Access Compliance Report

Public Rights-of-Way

Intersection ID: 11265	Main Street: N_TRYON_ST	Cross Street: WADSWORTH_PL	Location: S
ADA ID: 9A5EEB0D84D0	Ramp Type: Perp	Initial Pass/Fail: Pass	Overall Compliance: No
		Severity Score: 0.25

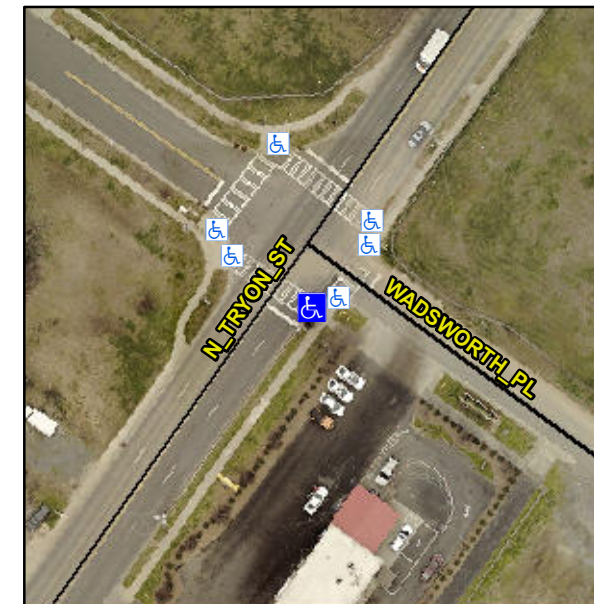
Not Found, R304.5.3, R302.7

Compliance	Description	Data	Compliance	Description	Data
N/A	Ramp Length (in)	59.0	Yes	Ramp Slope (%)	7.4
Yes	Ramp Width (in)	59.0	No	Ramp XSlope (%)	3.4
Yes	Flare Type L	Curbed_NoWalkSurface	Yes	Flare Type RT	N/A
Yes	Flare Slope LT (%)	N/A	N/A	Flare Slope RT (%)	N/A
N/A	Flare Traversable LT?	No	N/A	Flare Traversable RT?	No
Yes	Landing Length (in)	60.0	Yes	DWS Provided?	Yes
Yes	Landing Width (in)	59.0	Yes	DWS Contrast?	Yes
Yes	Landing Slope (%)	1.2	Yes	DWS Length (in)	24.0
Yes	Landing X Slope (%)	1.2	Yes	DWS Full Width?	Yes
N/A	Landing Curb? (Y/N)	No	Yes	DWS Offset (in)	0.0
N/A	Shared Landing?	Yes			
No	Gutter Ponding?	Yes	Yes	Gutter Slope (%)	2.4
Yes	Gutter Lip Ht (in)	0.0	No	Gutter X Slope (%)	3.8
N/A	Painted X Walk1?	Yes	N/A	Painted X Walk2?	N/A
	X Walk 1 Direction	To NW		X Walk 2 Direction	N/A
N/A	X Walk 1 Width (in)	117.0	N/A	X Walk 2 Width (in)	N/A
	X Walk 1 Slope (%)	5.9		X Walk 2 Slope (%)	N/A
	X Walk 1 X Slope (%)	2.8		X Walk 2 X Slope (%)	N/A

**Remove & Replace Entire Ramp.
Remove & Replace Gutter.**
